# SERVICE LETTER SL20 65-45100

**Part/Assembly #:** 65-45100

**Float Model Affected:** Aerocet Model 6650 Floats, Kodiak Aircraft

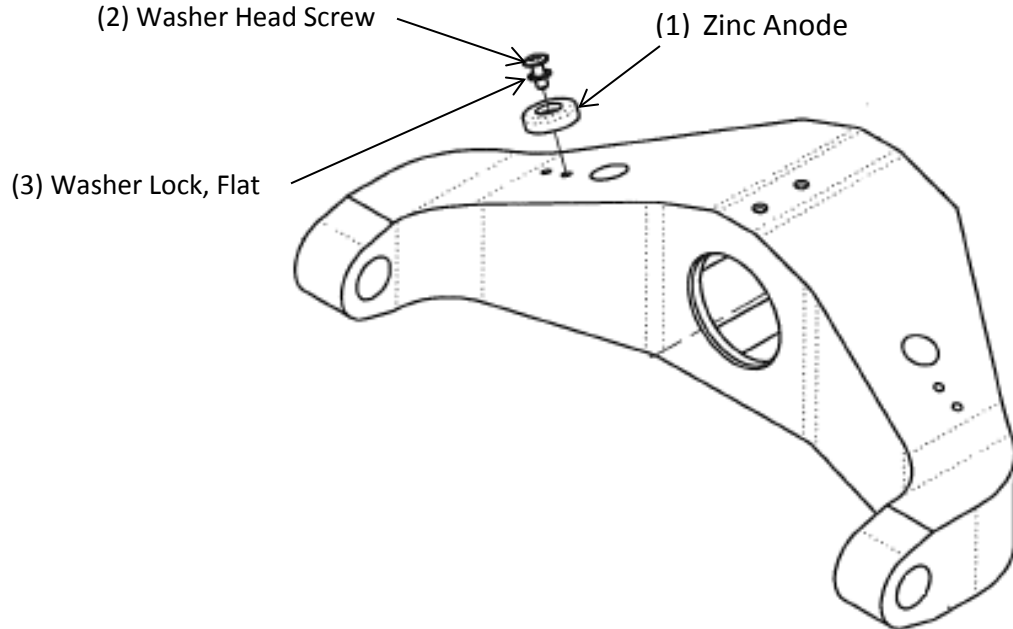
**Reason for Change:** To Increase anodic protections in the 6650 float gear.

1. Add optional installation of 35A-40120 Zinc Anode to unused, inboard #10-32 threaded hole.

2. Assure continuity between anode and assembly.
3. Chase threads if necessary to remove possible insulating debris or anodizing
4. Recommend filling the remaining, unused #10-32 outboard hole with Sika-Flex 292 or equivalent marine grade urethane sealant.
5. Apply Loctite Thread blocker Blue 242 to #10 fasteners upon installation.
